ADDENDUM

NO. 2

PROJECT NAME: New Operations Building

ADDENDUM DATE: Thursday, January 29, 2026

MECHANICAL ROOF PLAN

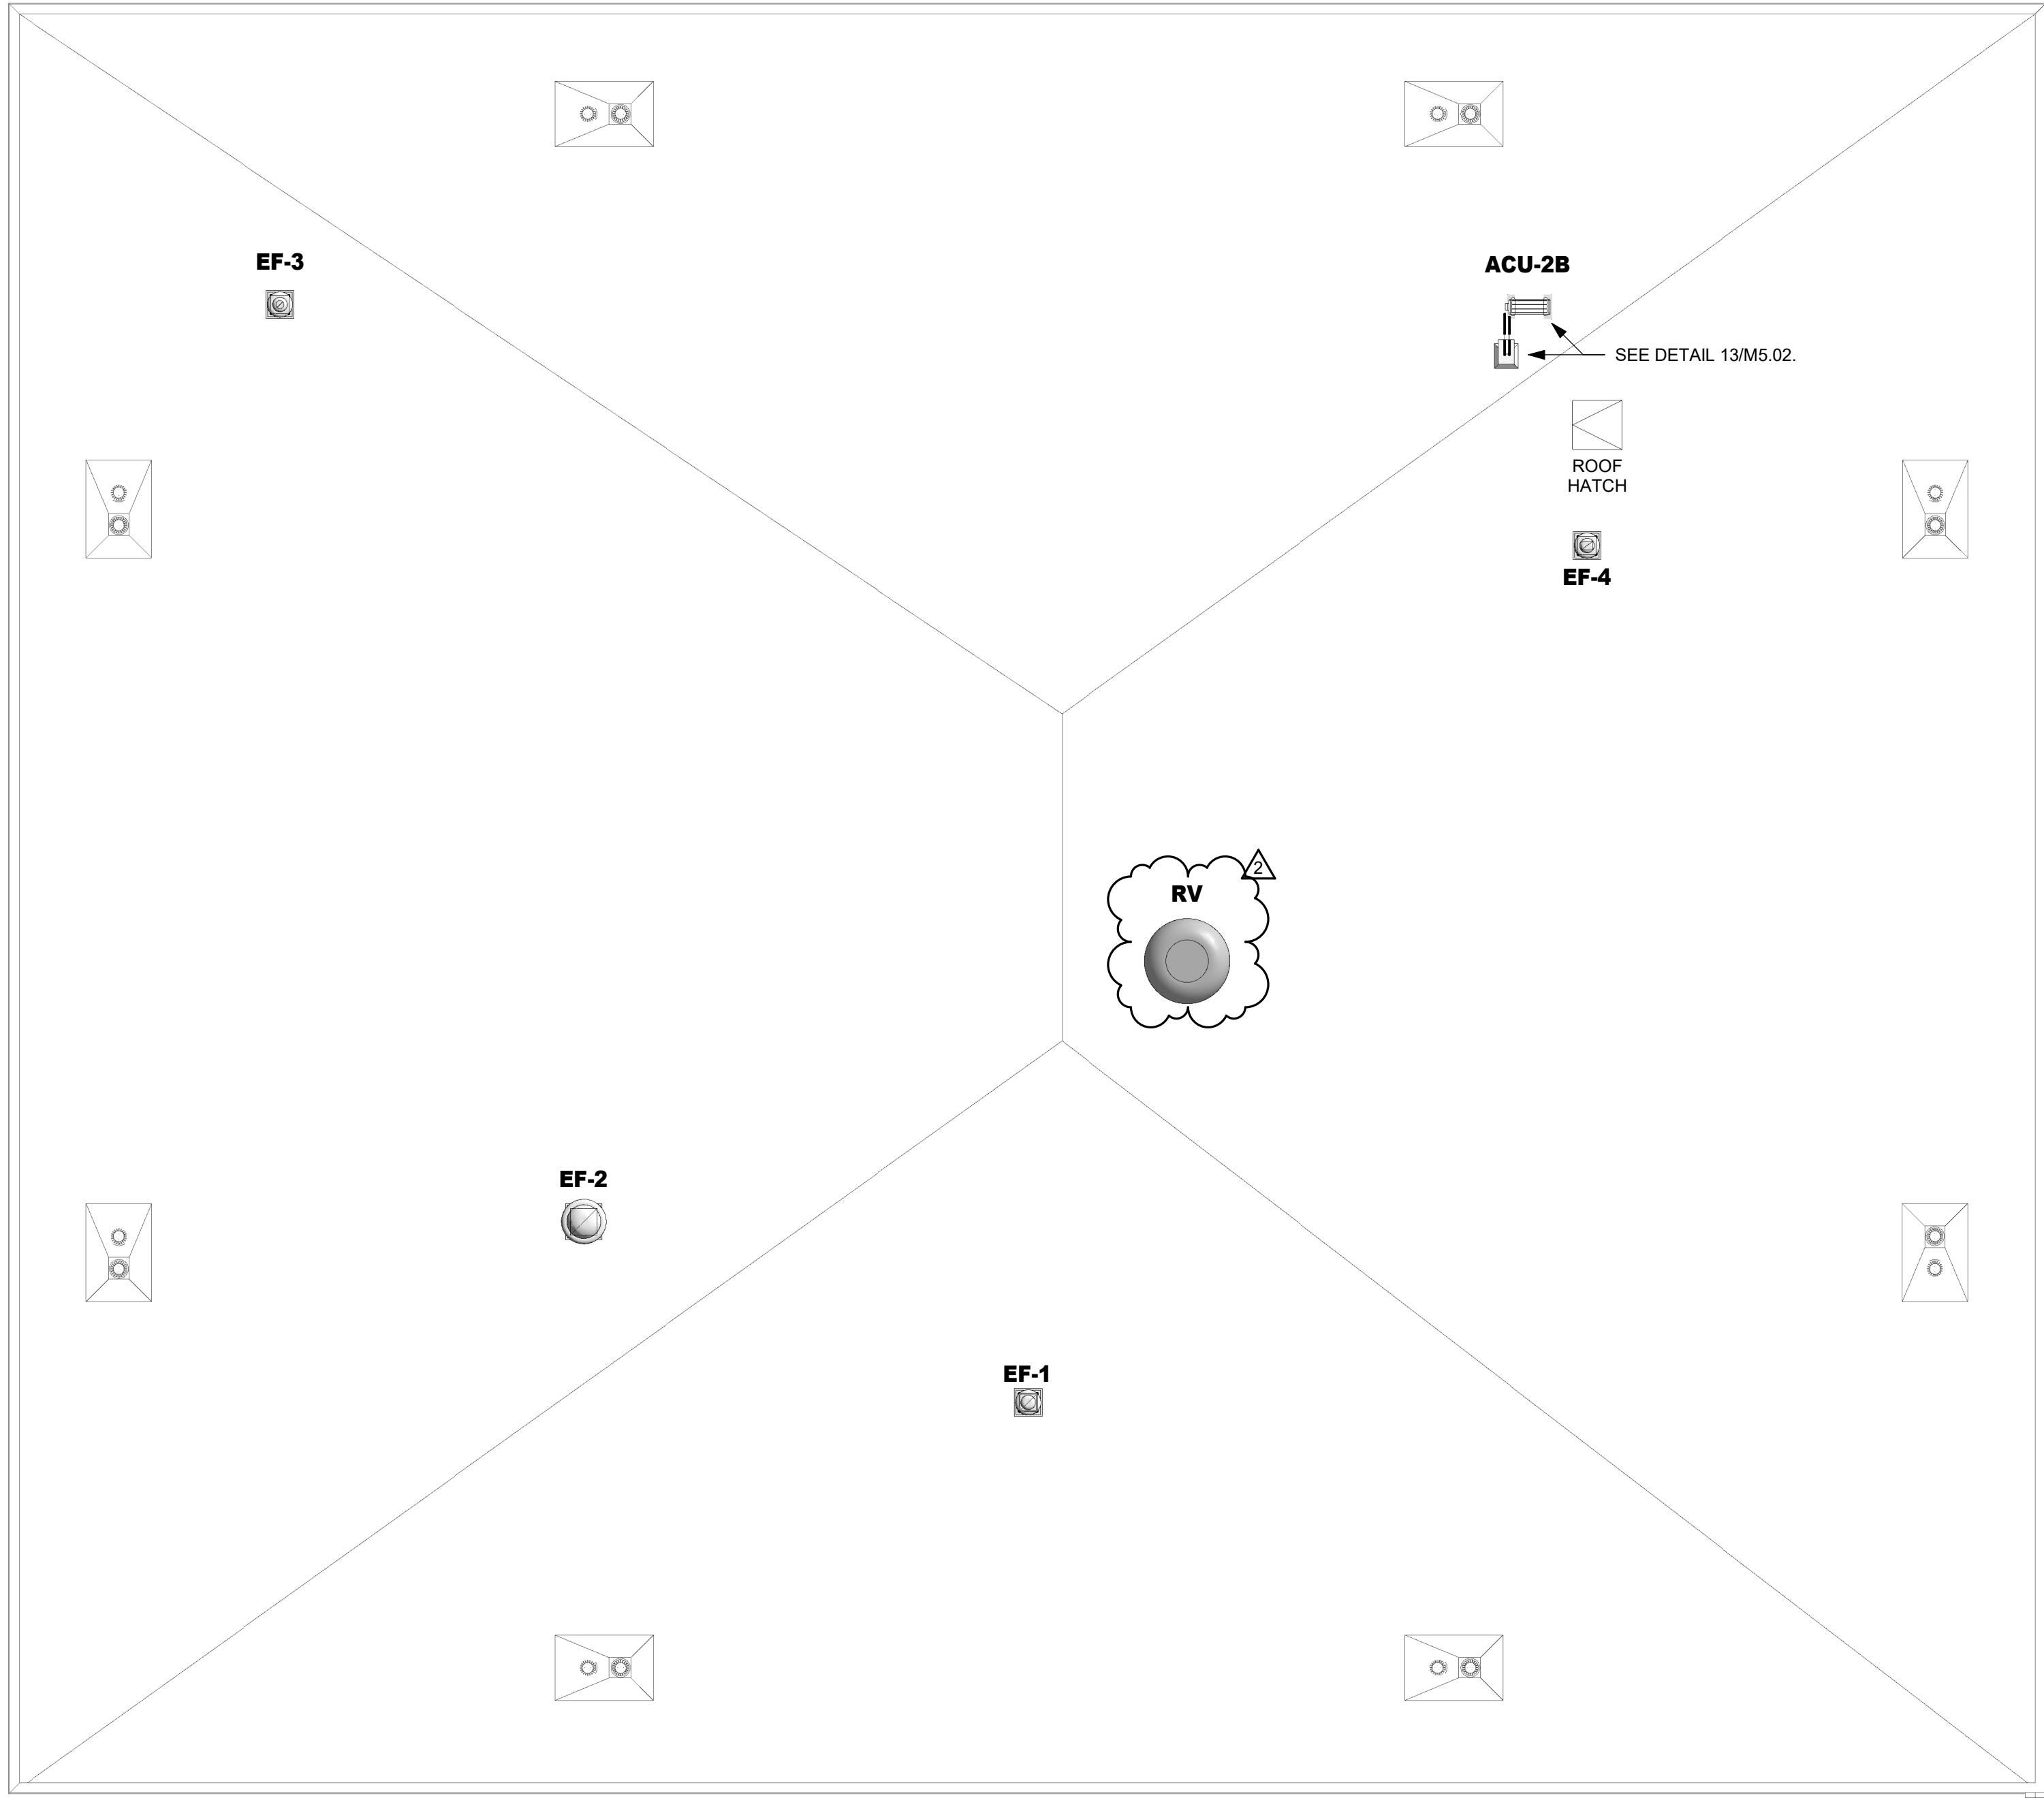
AD No 1, Mech. Item 2: To the Drawings, Sheet M1.06, "MECHANICAL ROOF PLAN,"

- 1) Add relief vent RV.

4 AHU-2 CONTROLS SCHEMATIC
NO SCALE

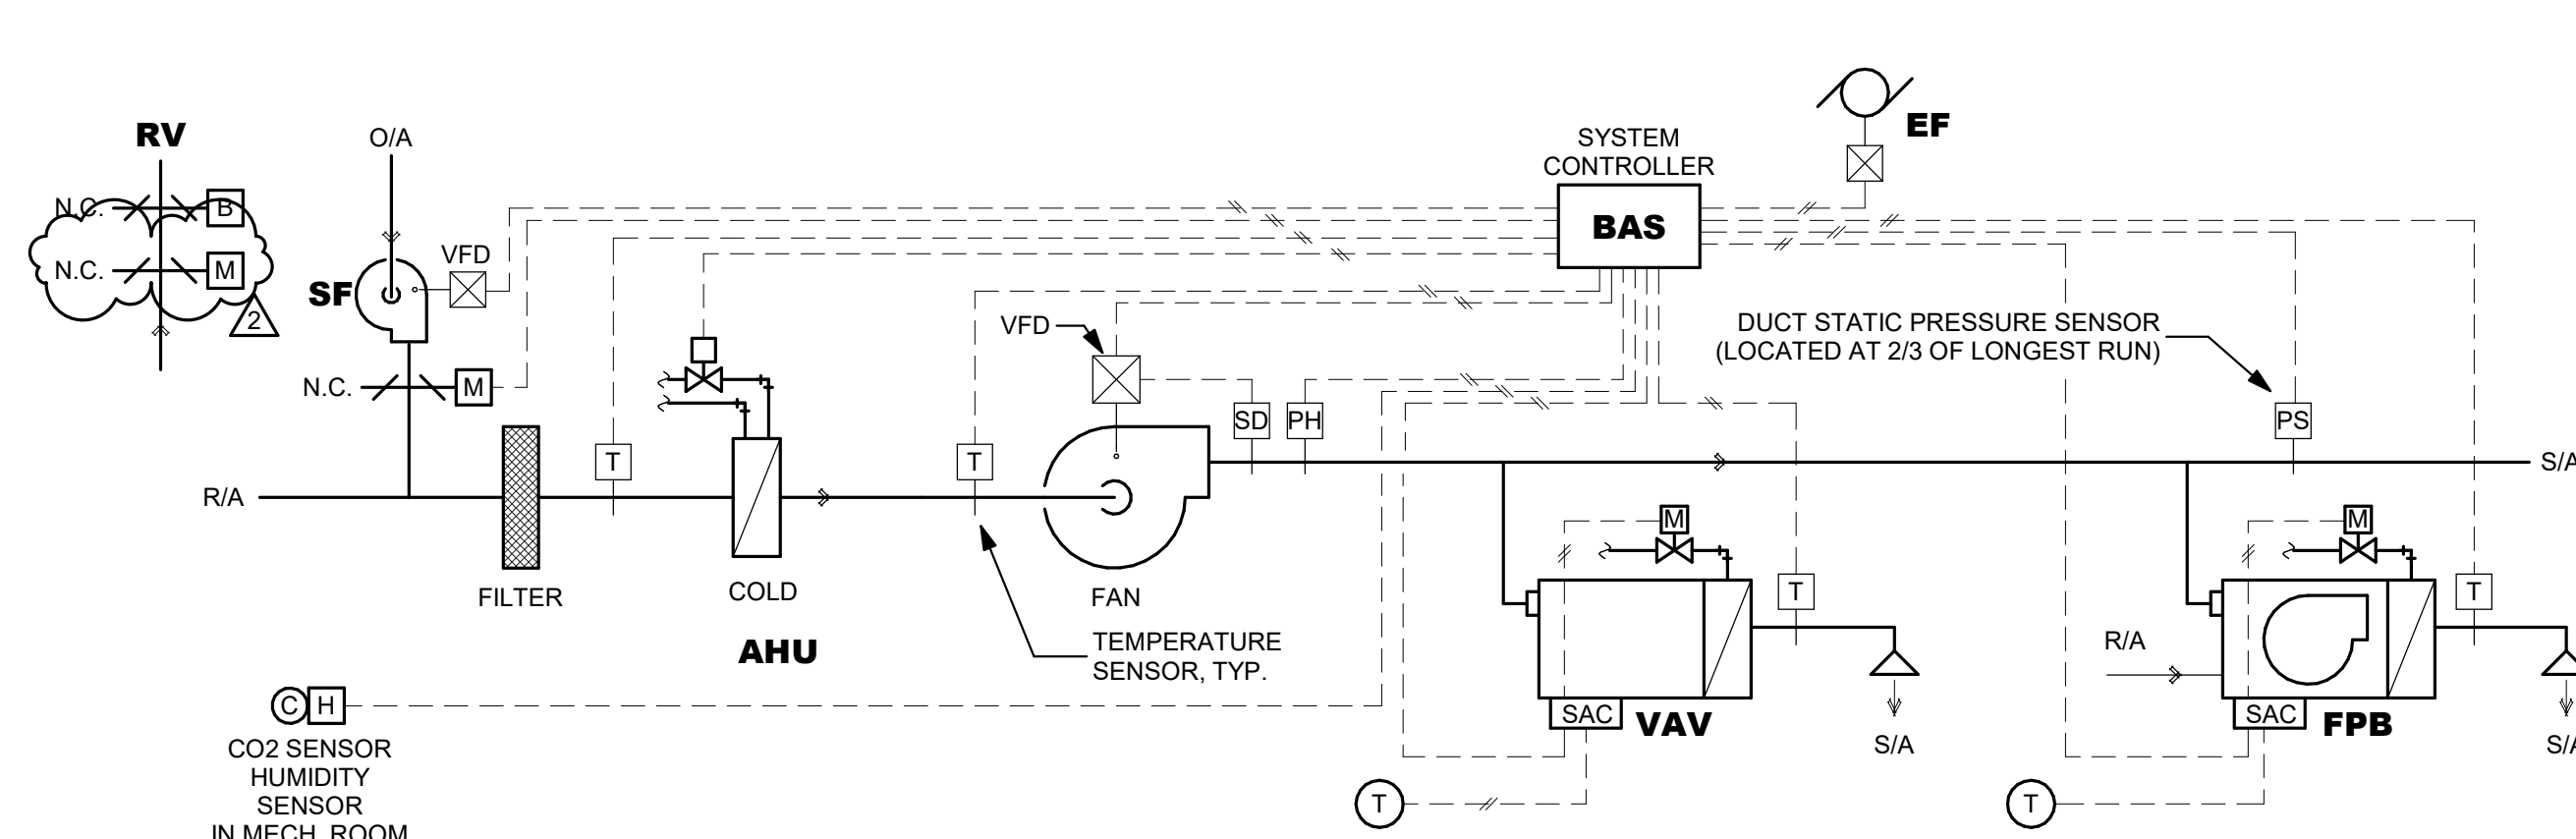
AD No 1, Mech. Item 5: To the Drawings, Sheet M6.01, "MECHANICAL SCHEMATICS,"

- 1) AHU-2 CONTROLS SCHEMATIC: Revise as indicated.

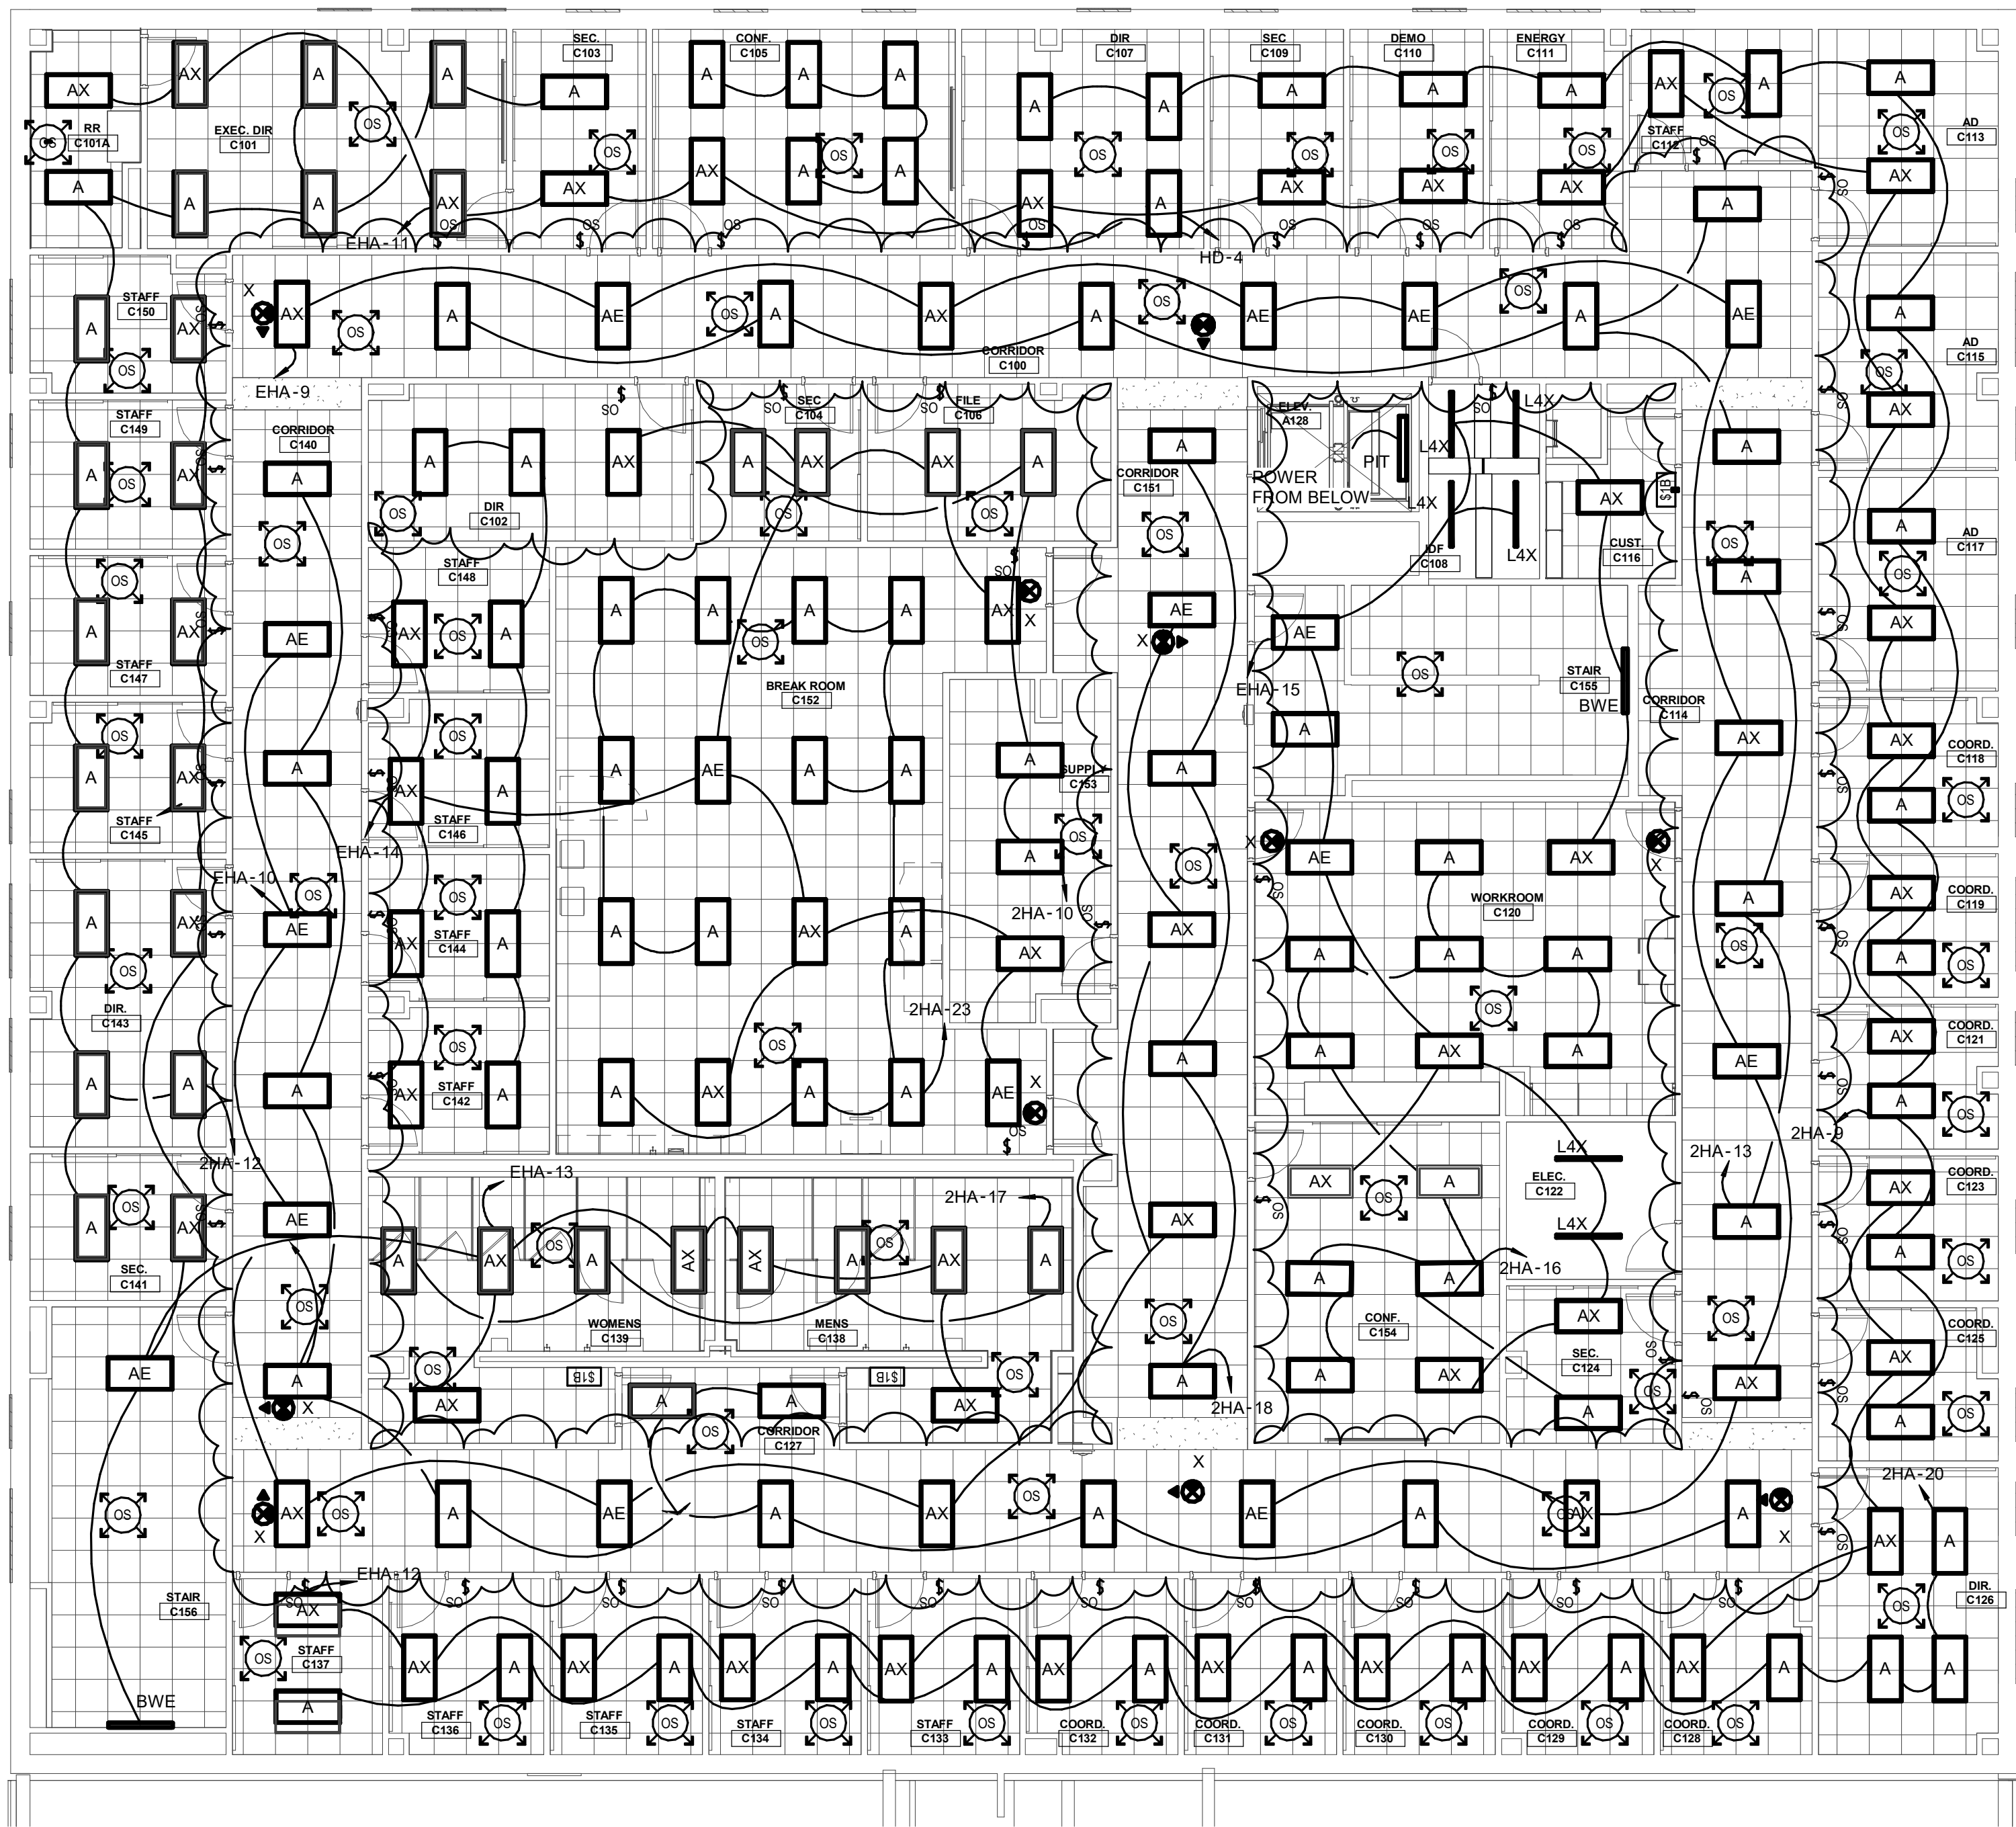
AD No 1, Elec. Item 1: To the Drawings, Sheet E2.02, "LIGHTING REFLECTED CEILING PLAN – LEVEL 1 / 2 – AREA A / C"

- 1) Revised lighting fixture layout.
